Product/Process Change Notification

Smaller Reel for Packaging Hermetically Sealed Products

Date: April 21,2016	ID Number (MMDDYY): PCN-011816-UMQ
Affected Products	Tantalum Hermetically Sealed/Axial Capacitors Series packed in tape and reel per cspec 7200: T110/T212 T111/T213 T140/T242 T210 T215 T216/T256 T220 T222 T225 T240 T245 T252 T255 T262

Comparative pictures of reels

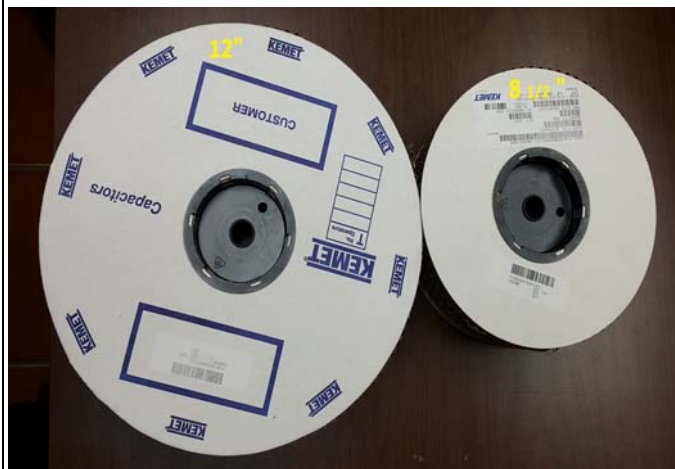
KEMET will begin shipping the affected products in either 8 1/2" reel or 12" reel, depending on the order quantity as shown below.

Component taping dimensions (per EIA RS-296), reel & packaging materials and information (labels) will remain the same.
